# Common Structural Rules for Bulk Carriers and Oil Tankers

## Technical Background for Rule Change Notice 1 to 01 JAN 2014 version

Pt. 1, Ch. 8, Sec. 5, Table 3

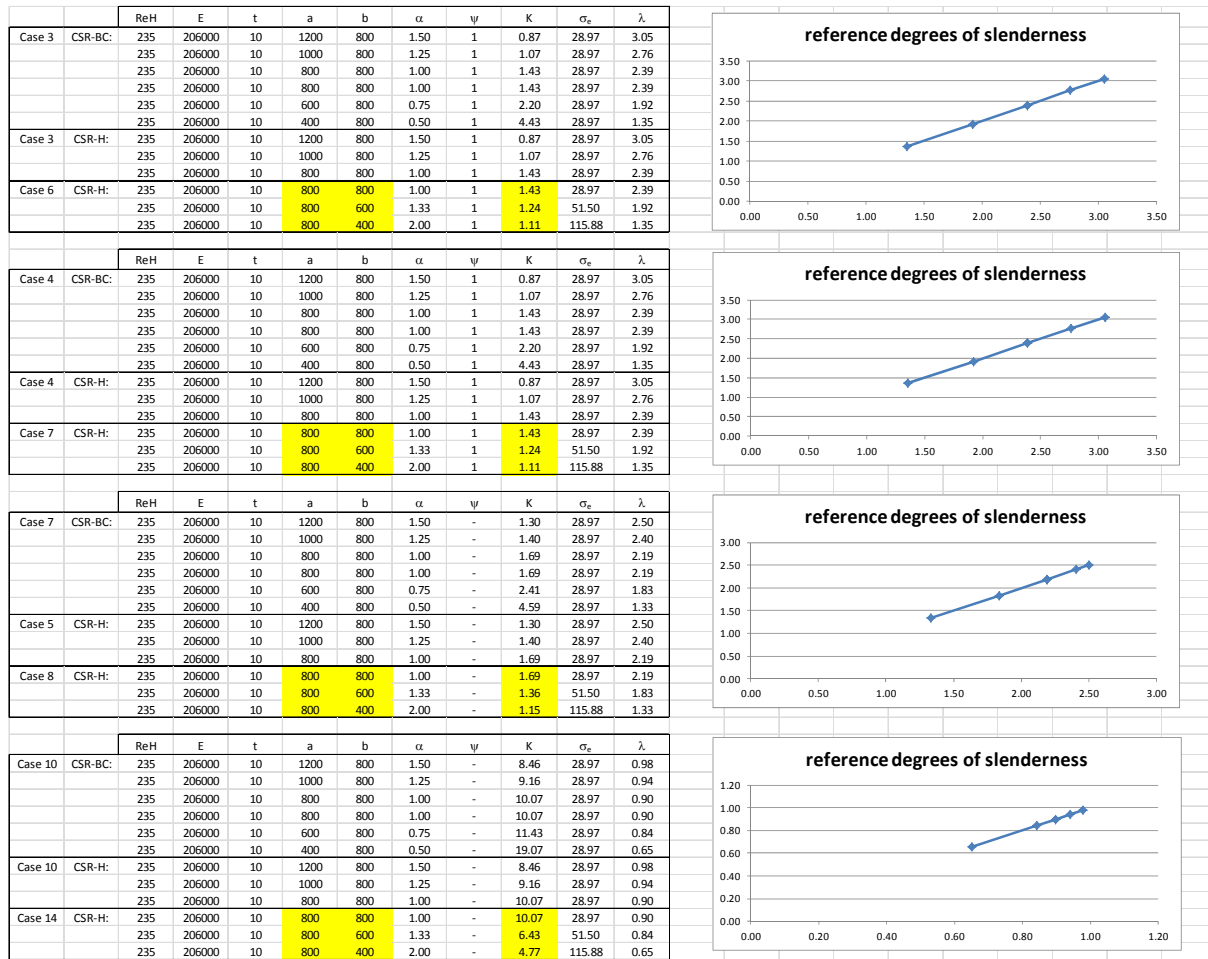
In both CSR-BC and CSR-H, the longer side of plating is assigned the symbol  $a$  and the shorter side is assigned the symbol  $b$ , where the aspect ratio  $\alpha = a/b$ . Accordingly, the aspect ratio  $\alpha$  is always greater than 1. However, in Table 3 of the CSR-BC buckling rules, equations for calculating the buckling factor  $K$  are provided for aspect ratios  $\alpha < 1$ . For the sake of consistency, the four (4) relevant equations are reformulated in CSR-H. The procedure is to invert all instances of  $\alpha$  and to divide the result by  $\alpha^2$  (to correct the elastic buckling reference stress  $\sigma_E$ ).

In addition, for the buckling assessment of plates in way of openings/manholes without edge stiffening, i.e. geometries where the opening ratio exceeds 70%, cases covering the shear strength were missing. Accordingly, two (2) new load cases have been developed for calculating the buckling factor  $K$  of plates with one free edge (including validation of the existing equation for the reduction factor  $C_T$ ).

The six (6) new load cases are summarised in Tables 1 and 2.

Figure 1: Validation of procedure for reformulating equations

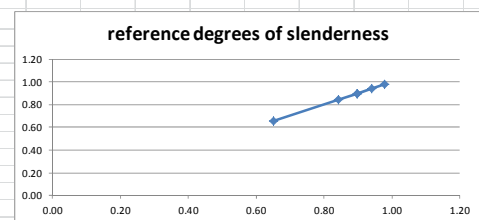
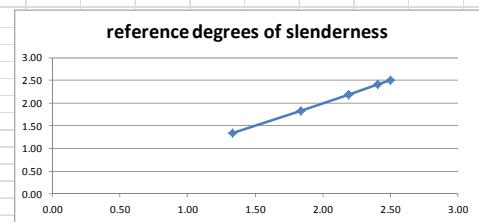
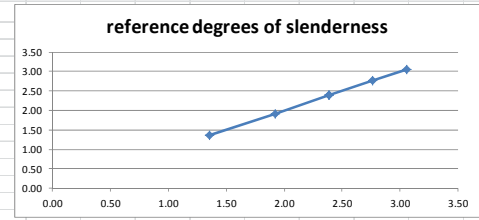
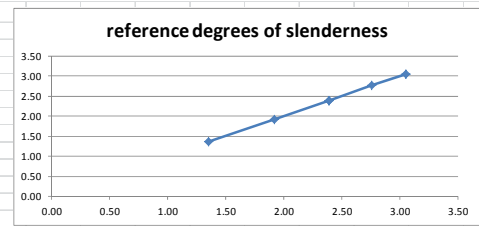
1) New load cases 6,7,8 and 14:

The following comparisons of reference degrees of slenderness  $\lambda$  validate the procedure for reformulating the equations used to calculate the elastic buckling factor K, where:

**Figure 2: Typical deflection plots**

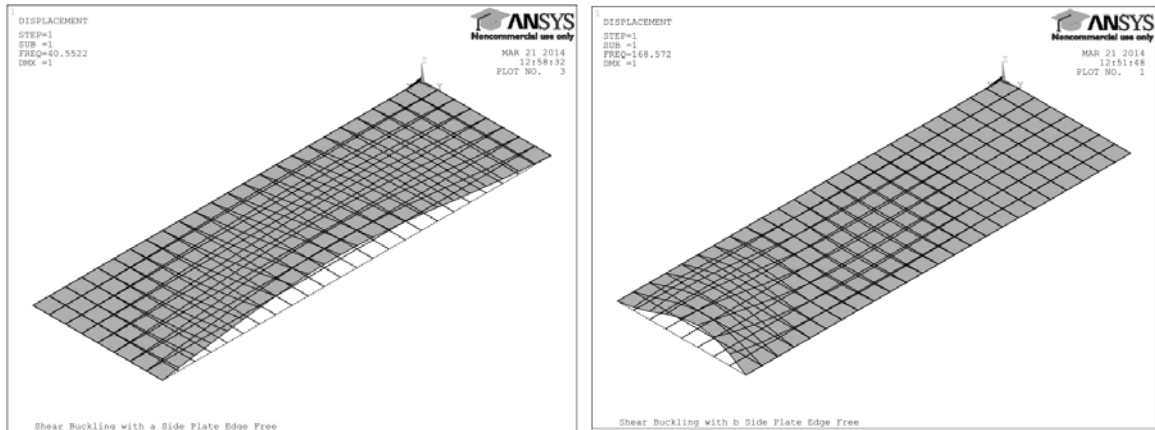
Typical deflection plots for the new load cases are shown in Figure 2.

For the free b-side, the effect of aspect ratio  $\alpha$  is negligible, i.e. all of the buckling takes place at the free end (see Figure 2).

**Figure 3: Elastic buckling comparison plot**

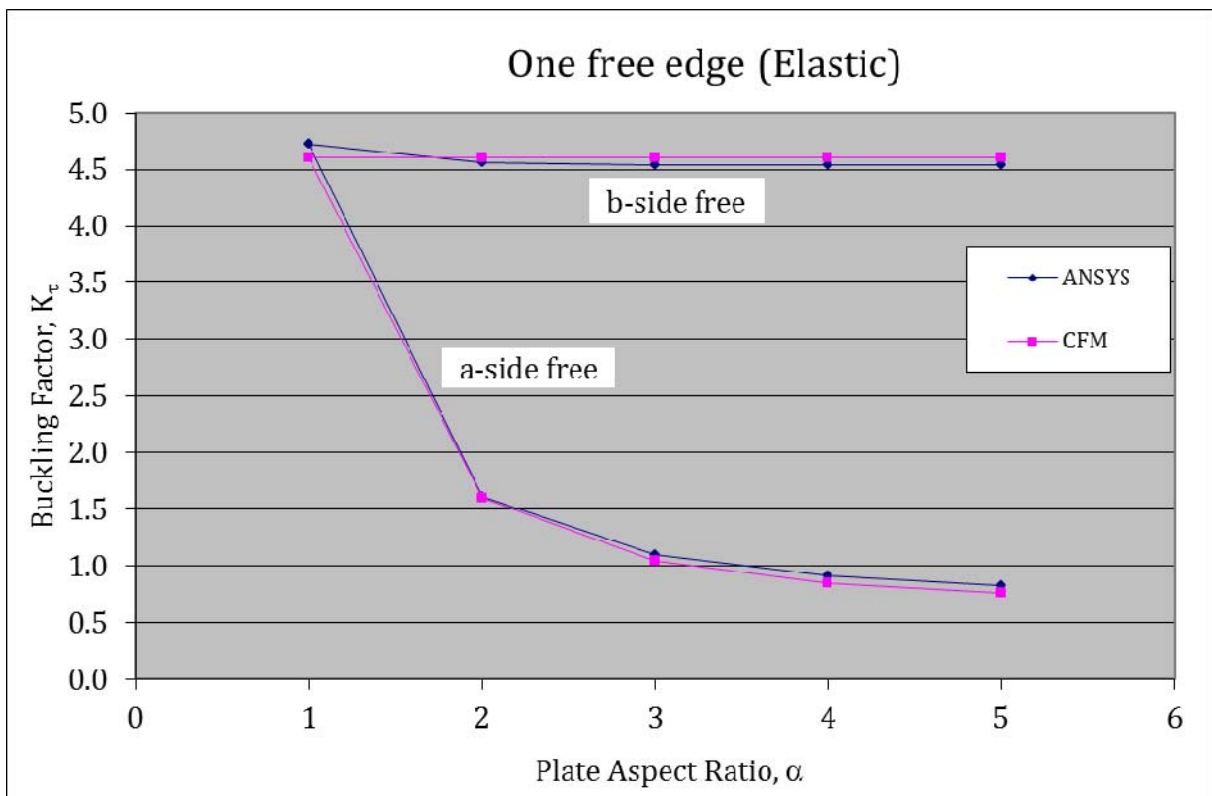
Results of the FE analyses are shown in Figure 3.

Based on these FE results, the buckling factor  $K$  can be calculated as follows:

a-side free (Case 18):  $K = 0.6 + 4/\alpha^2$ , and

b-side free (Case 19):  $K = 0.6 + 4/1^2 = 4.6$ .

These CFM formulae are compared to the FE results in Figure 3.

Figure 4: ULS comparison plot

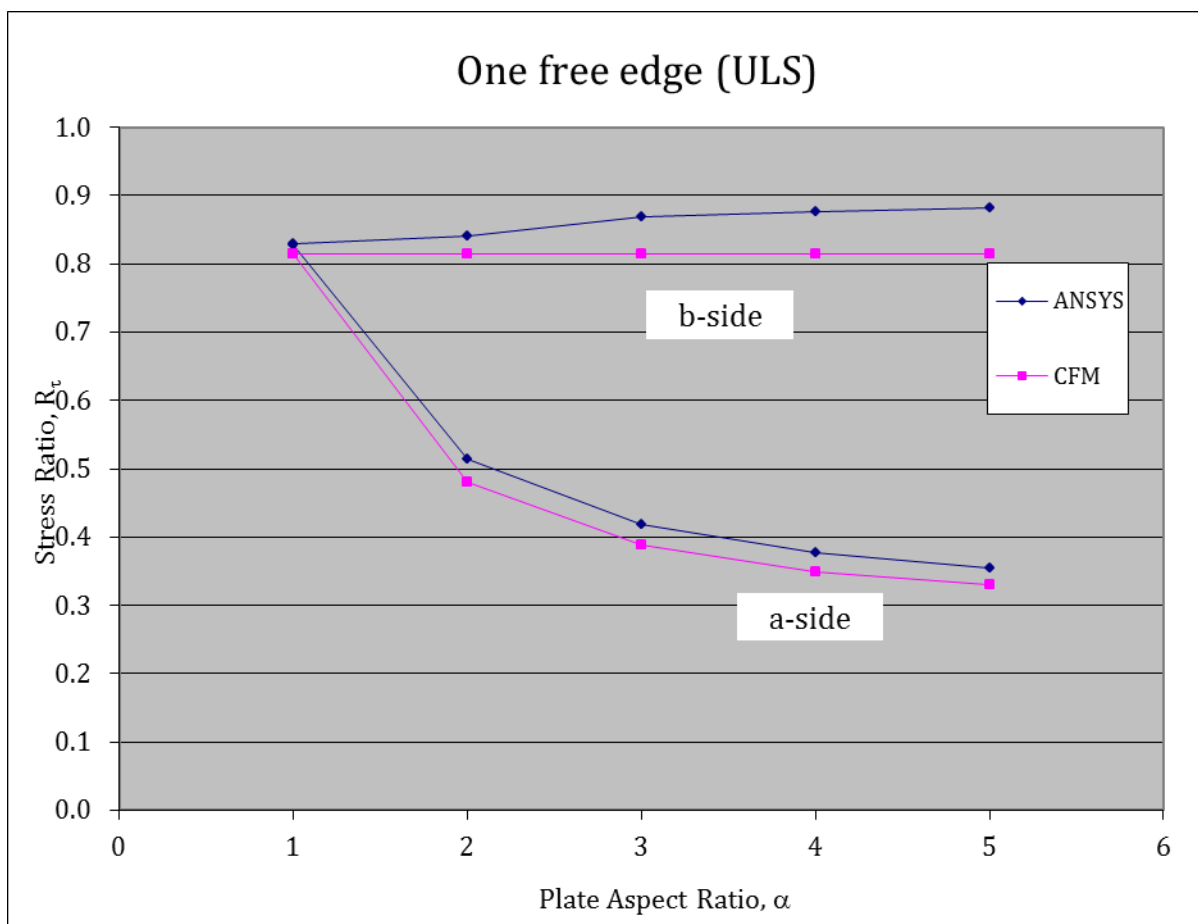
A plot comparing CFM and FE results is shown in Figure 4. The comparison validates the existing CFM equation used to calculate  $C_\tau$ .

Figure 1

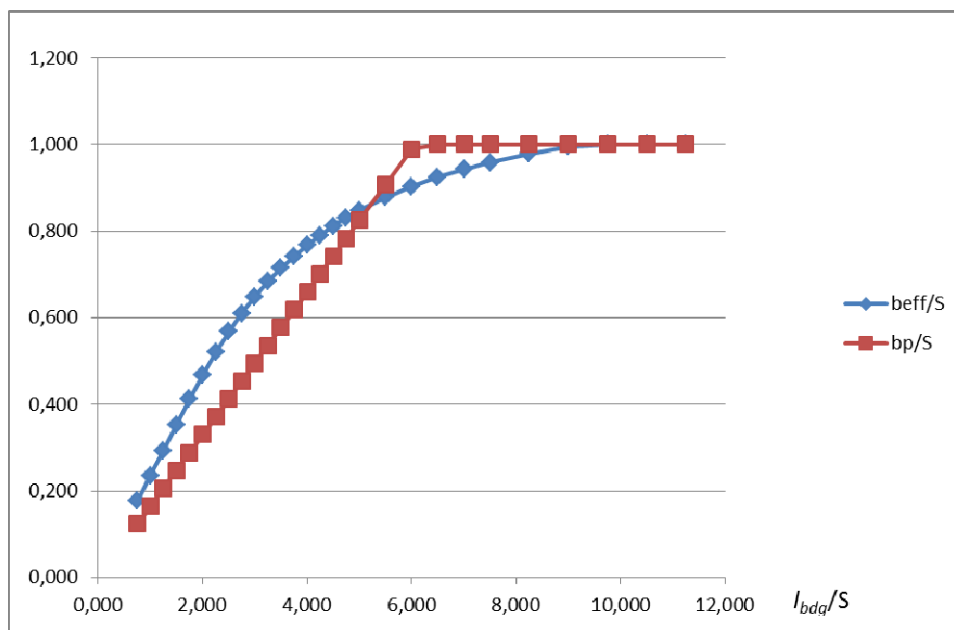
The reason for this Rule change proposal is to align the method of calculating effective width of attached plating of primary supporting members of cargo hatch covers with the general method used for all hull structures given in Pt 1 Ch 3 Sec 7 [1.3.2].

The consequences of this Rule change proposal is expected is illustrate in figure 1, red curve is current formulation and blue curve is the proposed method. The impact on scantlings will be dependent on length/spacing ratio of the member. For ratios less than 5 (in general short members) the proposed formulation will give increased effective width and potentially lower scantling requirement than current formulation. For ratios between 5 and 10 the effective width will be reduced, i.e. the scantling requirements will increase. For these longer members the bending stresses of the primary supporting members are important to check for yield in the face plate and buckling of the attached plate, hence possible non-conservative results with the current formulation will be removed. For length/spacing ratios exceeding 10, i.e. very long members, both the proposed formulation and the current method will give 100% effective width.
